1                   **SUPPLEMENTAL REPORT OF PROFESSOR G. MATHIAS KONDOLF, PH.D.**

2  
3                   I was asked by Natural Resources Defense Council to review the expert reports of Drs.  
4 Charles Hanson, Michael Harvey, Rod Wittler, Clair Stalnaker, Don Smith and Joseph  
5 Kubitschek regarding the flow and non-flow measures necessary to restore salmon fisheries to  
6 good condition in the San Joaquin River below Friant Dam. I address three topics below: (1)  
7 uncertainty regarding the impact of a restoration flow schedule on these fisheries, (2) the  
8 magnitude of the flow schedule, and (3) non-flow measures necessary to restore these fisheries  
9 to good condition.

**Figure 1. Comparison of Kondolf and Hanson Recommended Dry Year Restoration Flows at Friant Relative to Average Calculated Dry Year Unimpaired (1896-1999)**

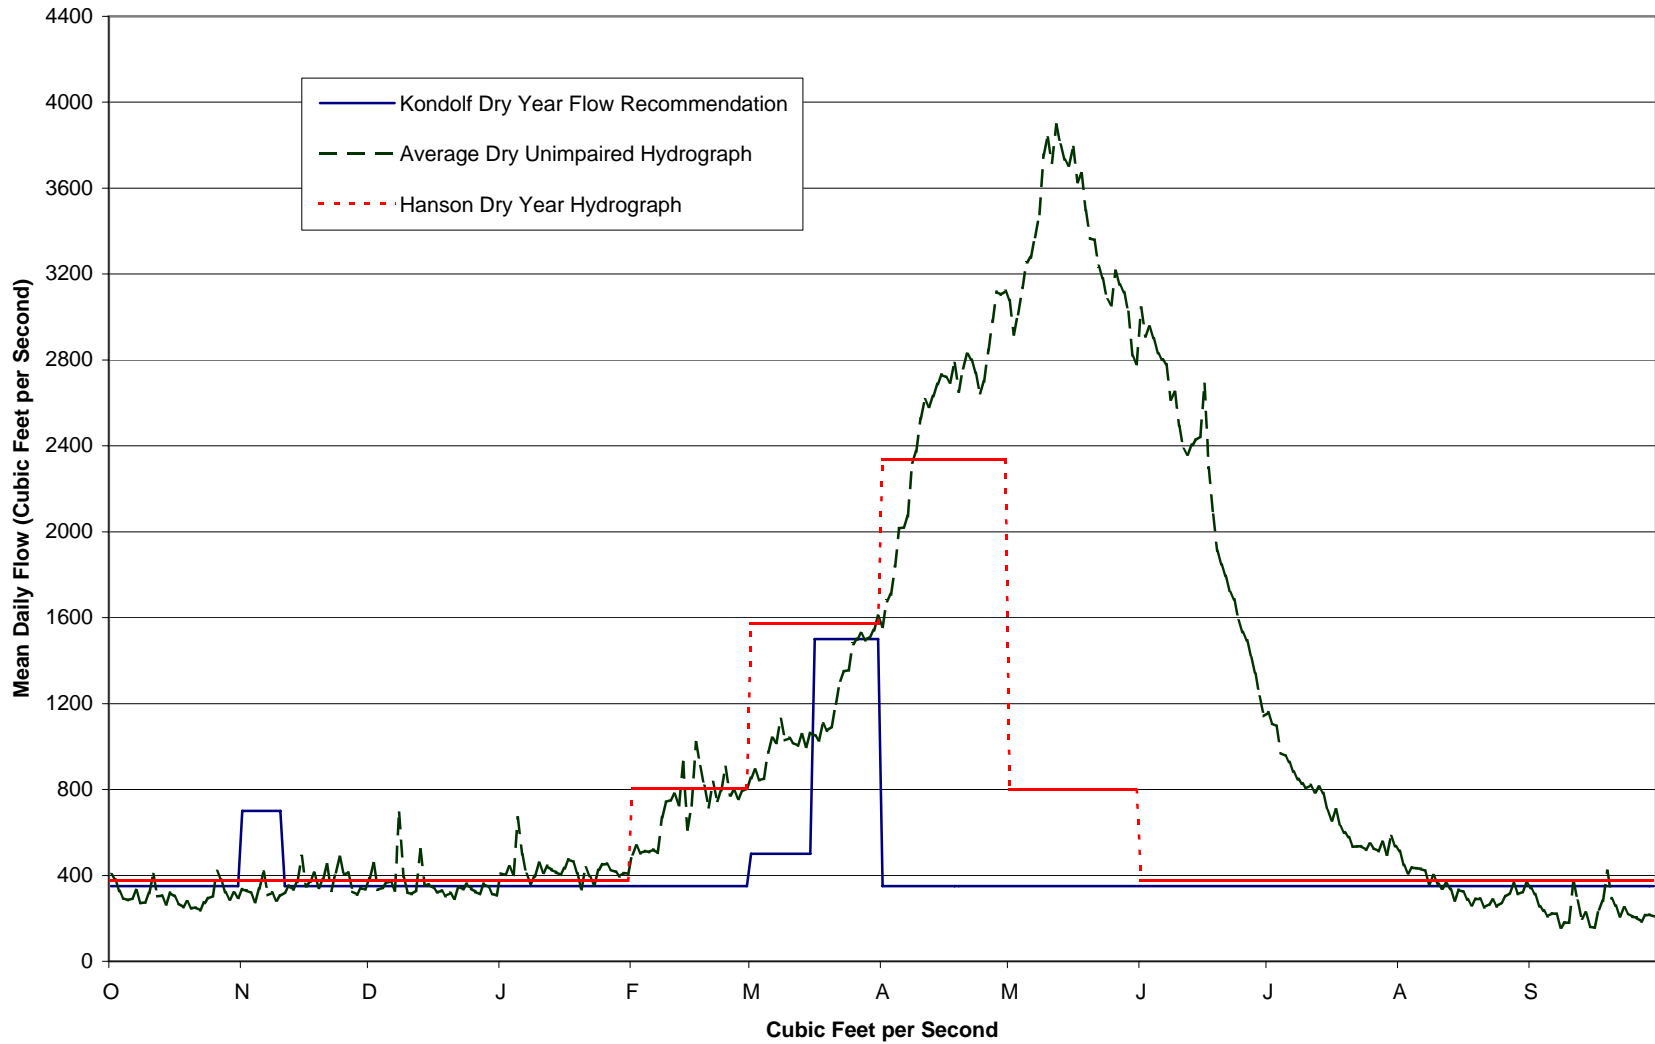
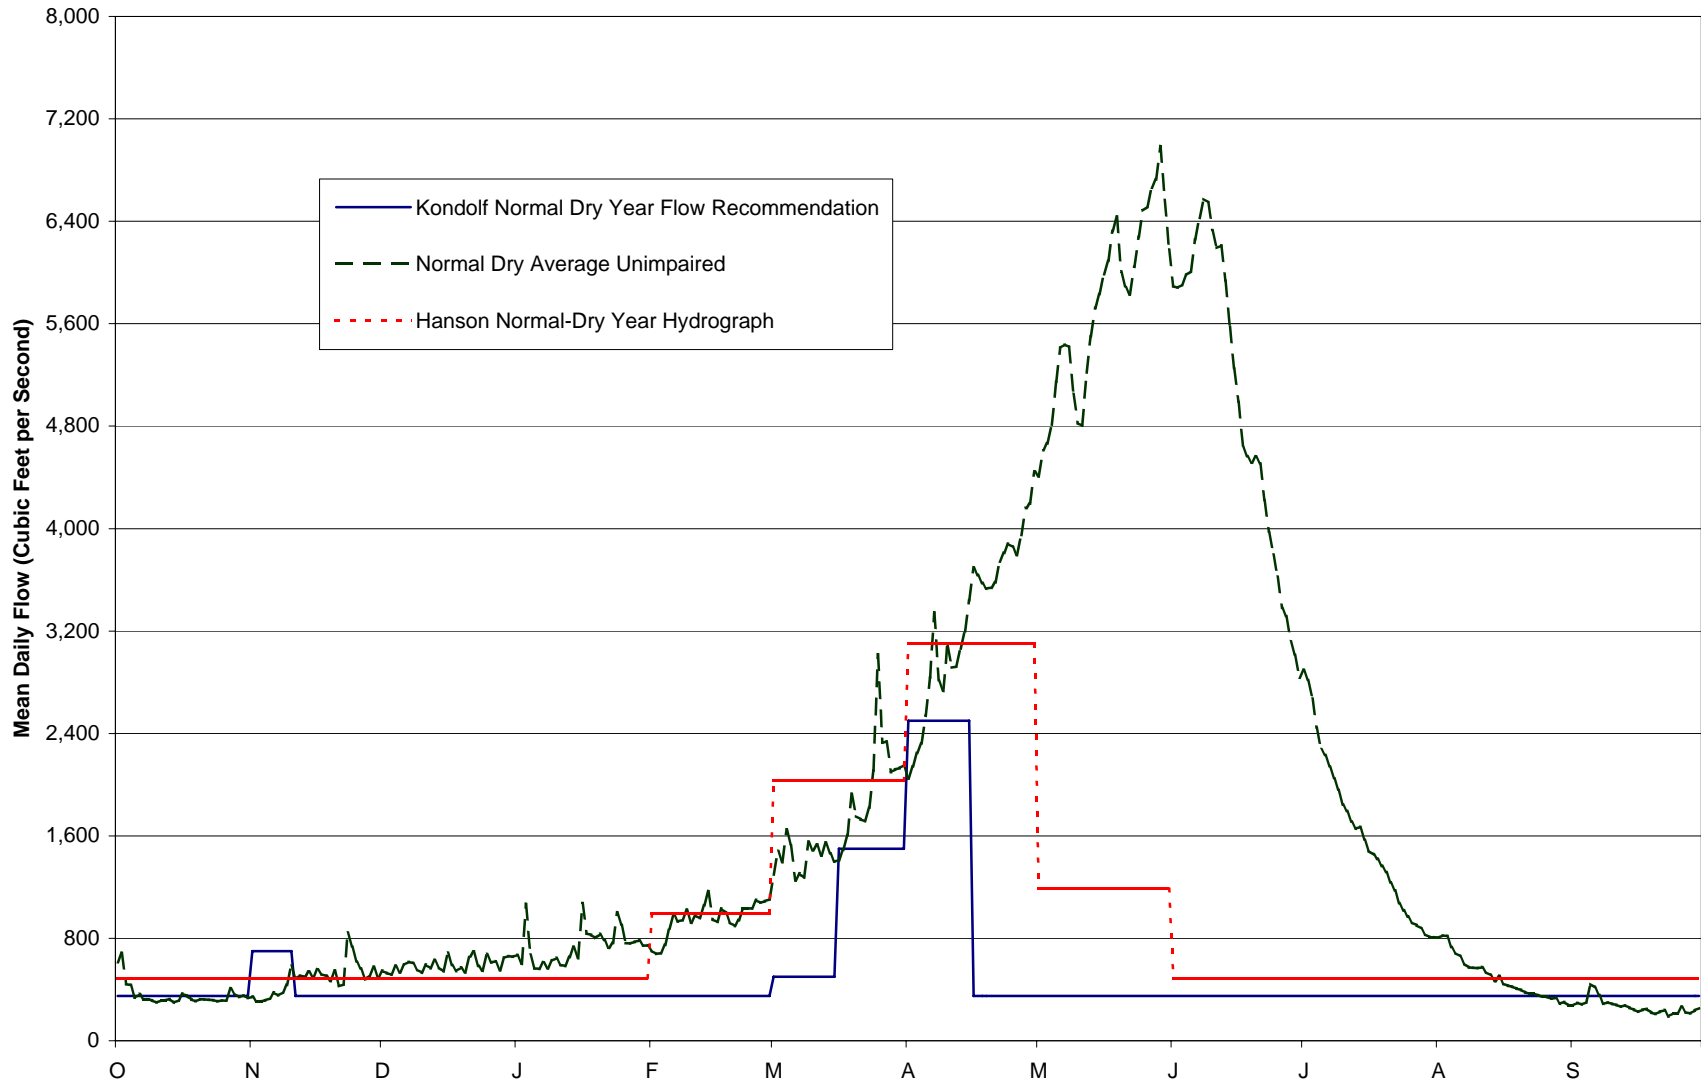
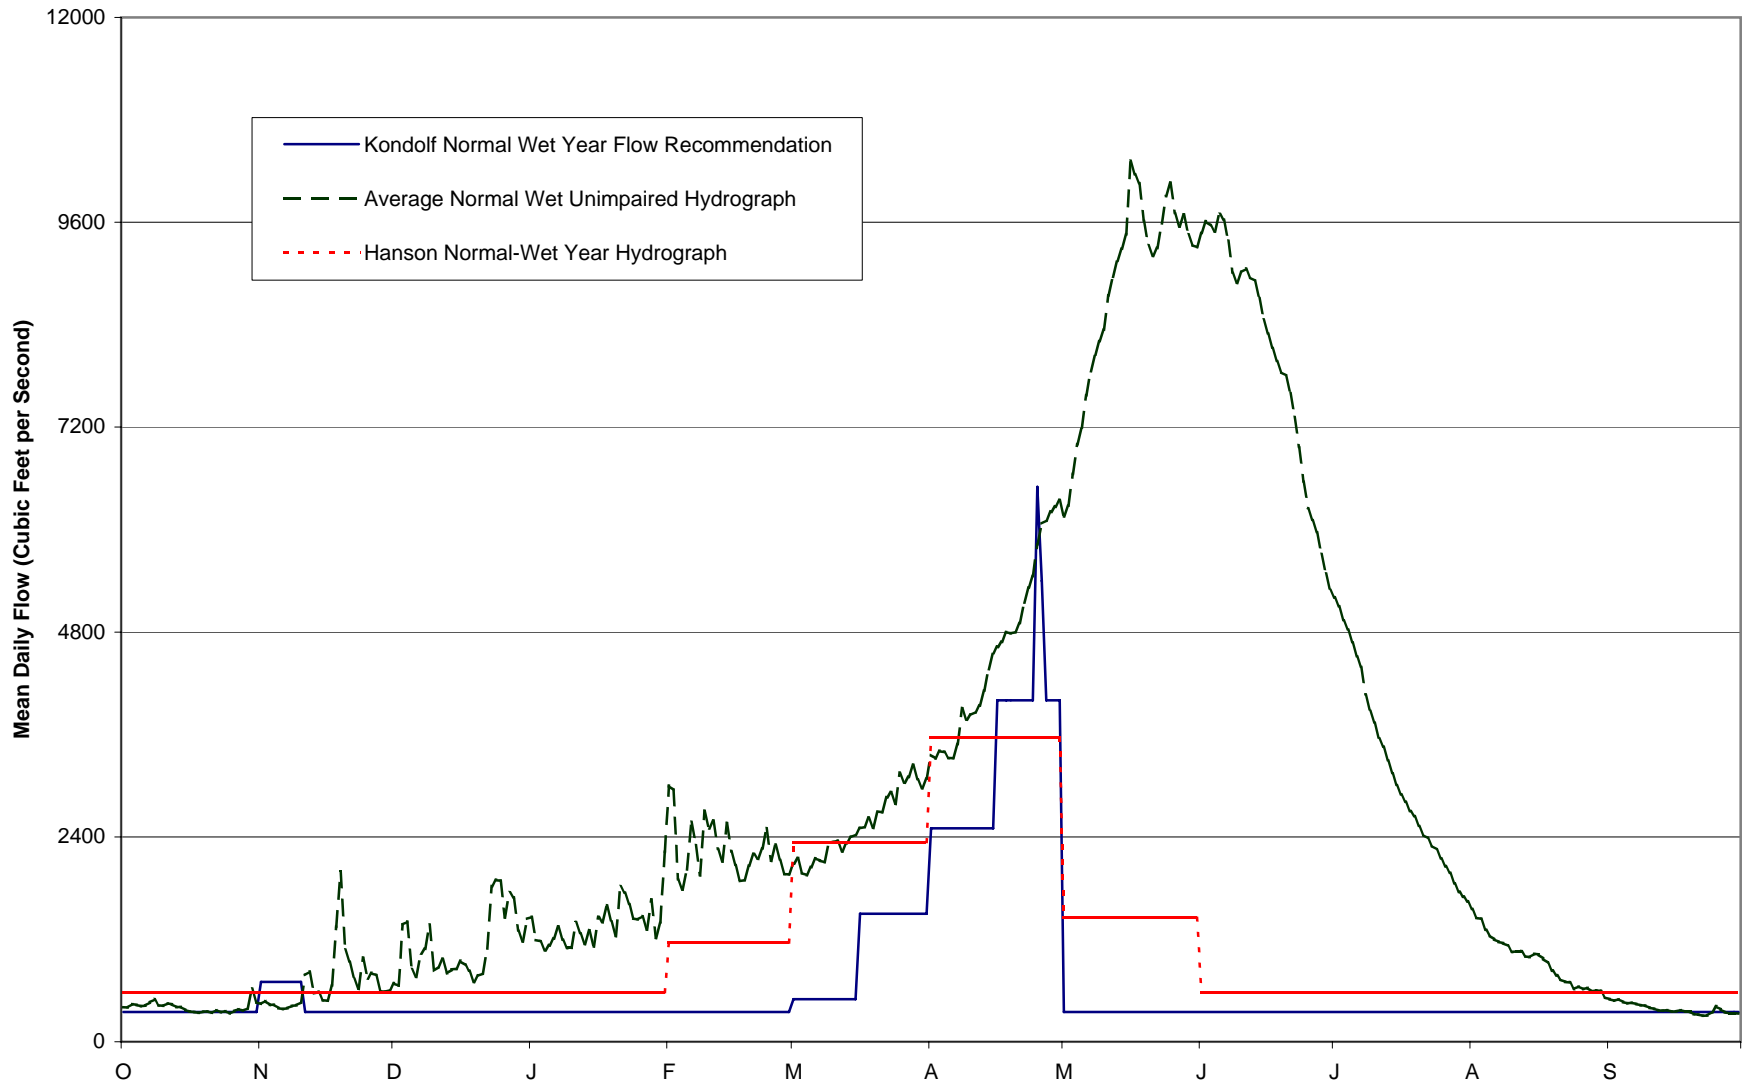
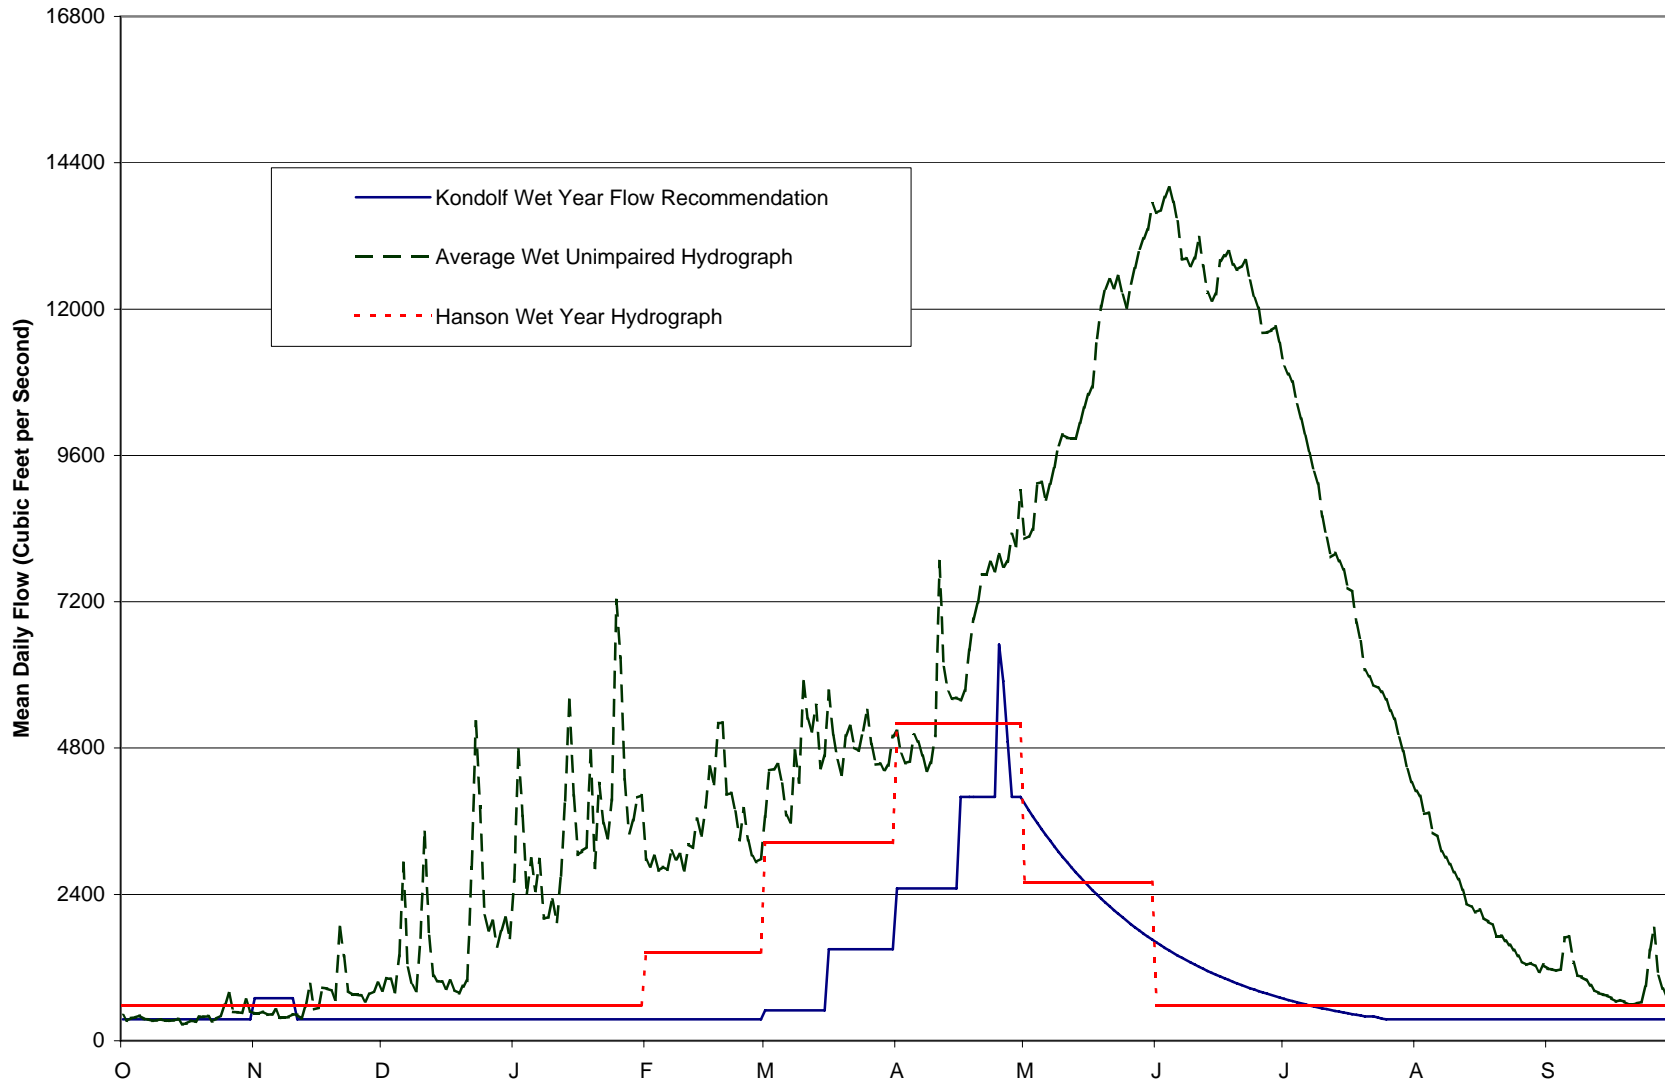
- 20 17. Specifically, for all year types, Dr. Hanson's restoration hydrograph overstates:  
21 a. the magnitude of base flows needed to restore and maintain salmon during  
22 the late spring through late winter months,  
23 b. the amount of flows necessary for upstream and downstream salmon  
24 migration in February and early March,  
25 c. the volume of water necessary between mid-march and late April necessary  
26 to maintain temperature and otherwise support migration of juvenile and  
27 adult salmon, and  
28 d. the amount of water necessary to ramp flows down from the spring pulse to  
the summer base flow.

1           18.       Figure 1 (end) illustrates the excess water for each of these hydrograph  
2 components which cumulatively result in restoration flow volumes that on average result in  
3 more than 1.7 times more flow than I recommended for salmon restoration in my previous  
4 report. Furthermore, since Dr. Hanson's hydrograph lacks a critical year category, his dry  
5 year recommendation requires over 3 times more water on average than the critical dry year  
6 recommendation I provided in my report. Perhaps the key difference is that Dr. Hanson  
7 proposes to restore the San Joaquin River to a largely unimpaired condition, whereas Dr.  
8 Moyle and I propose reconciliation, in which we restore anadromous salmon, while still  
9 allowing diversions to support other human uses.
